# RotorSport UK Ltd Service Bulletin (Permit)

| <b>Title: Improved Cavalon 915is oil cooling system</b>  |  | <b>Release date 10.10.2020</b>   |
| <b>SB-137 Iss1</b>   | <b>Related documents</b><br>Modification:<br>CCAR No.: None  | <b>Compliance Category:</b><br><br><b>OPTIONAL</b> <del>or</del><br><b>RECOMMENDED</b> <del>or</del><br><b>MANDATORY</b> |

| <b>Title: Cavalon Oil Thermostat Assembly Upgrade</b>  |  | <b>Compliance Category:</b><br><br><b>A – MANDATORY</b><br><b>B – RECOMMENDED</b><br><b>C – OPTIONAL</b> |

(Pic. 1)

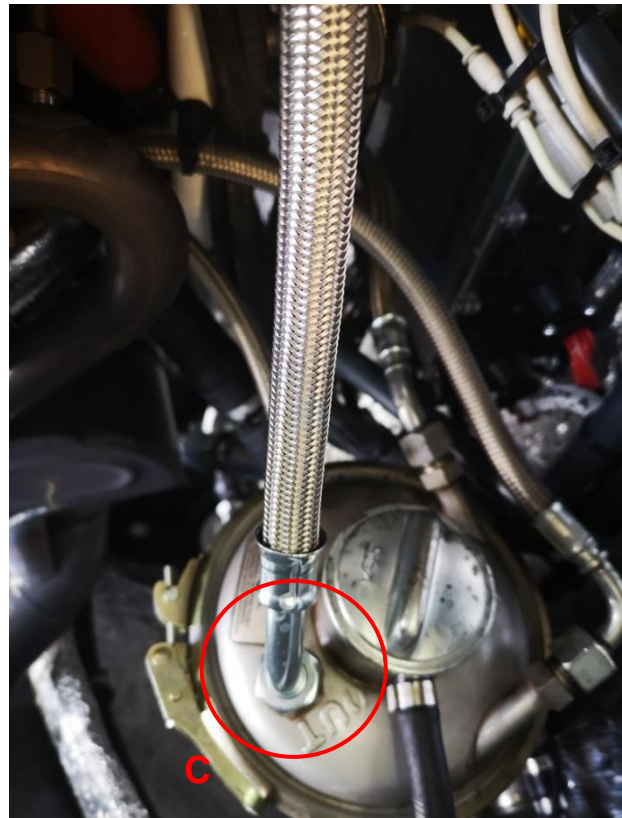
4. Confirm the size of the adaptor at the oil pump (Pic. 1 item A). If the thread size is anything other than 22mm then it must be replaced with adapter **45583**. If the thread is 22mm then no further action is required.

6. Return the oil in the system to the tank by turning the propeller until a gurgling sound is heard.
7. Place a container under the oil pump at the rear of the engine, and disconnect the oil hose (Pic. 1, item A). Allow any oil to drain and remove the P-clamp (Pic. 1, item B).

(Pic. 3)

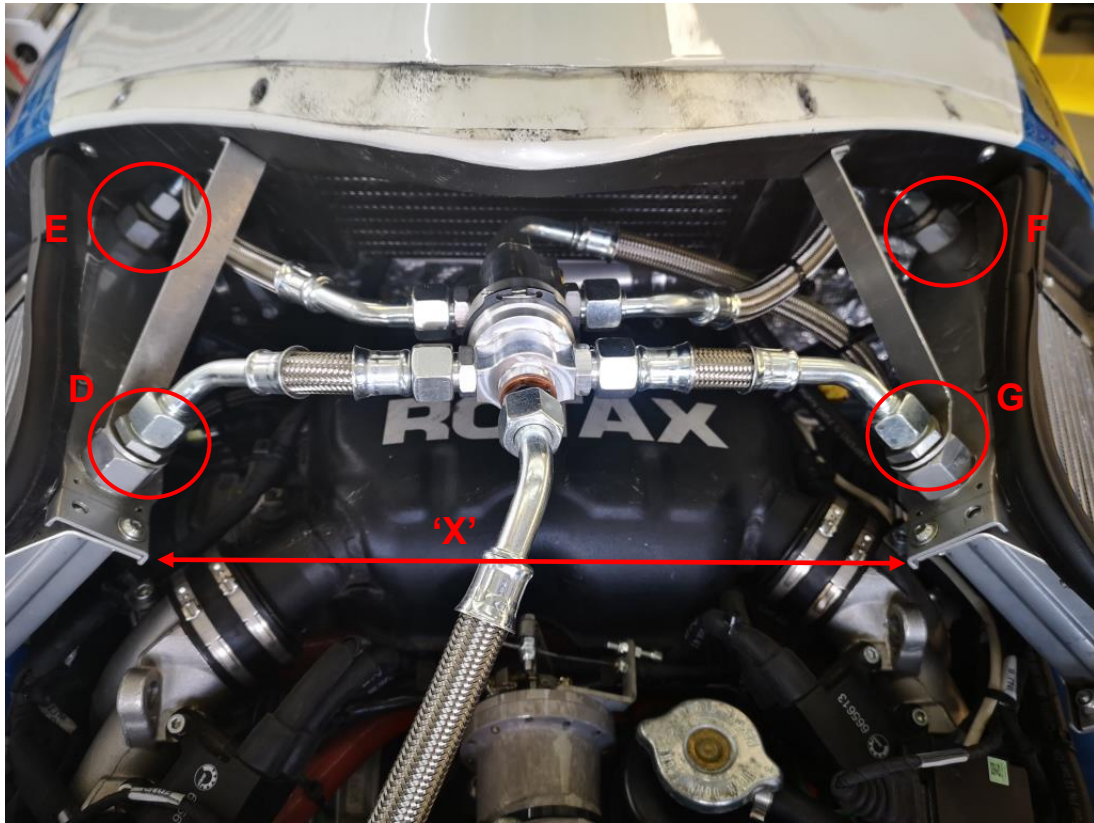
1. Ensure the wheel brakes are applied and the mag switches/ignition are switched in the "off" position.
2. Remove the upper and lower engine cowlings.
3. Measure the distance between the oil cooler corners as shown in Pic. 3 dimension 'X' to determine which hose set is required. If dimension 'X' is 280mm then oil hose set **47896** is required, if dimension 'X' is 335mm then oil hose set **47817** is required.

8. Disconnect the return hose from the right side oil cooler at the oil tank connection (Pic 2, item C)
9. Place a container under the oil cooler hose connections and disconnect the 4 hoses from the oil coolers (Pic 3. Items D, E, F & G). NOTE: Ensure to counter the adapters when dis-assembling and assembling the hoses on the coolers.  
Note: The thermostat and hoses are now supplied as separate items.

(Pic. 4)

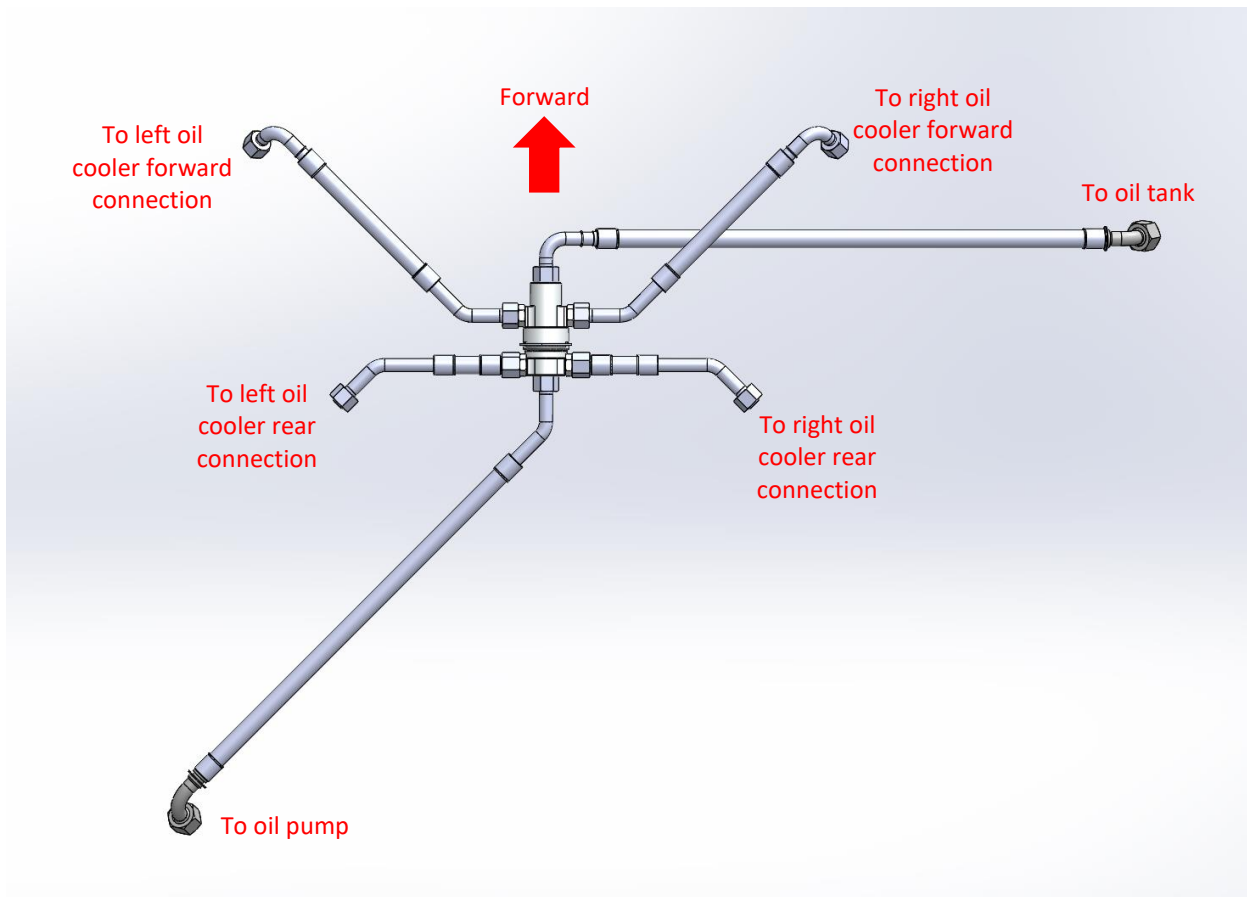
10. Assemble the new hoses (47896 or 47817) to the new thermostat (47748) loosely. Ensure that the items are assembled in the correct orientation as shown in Pic. 4.
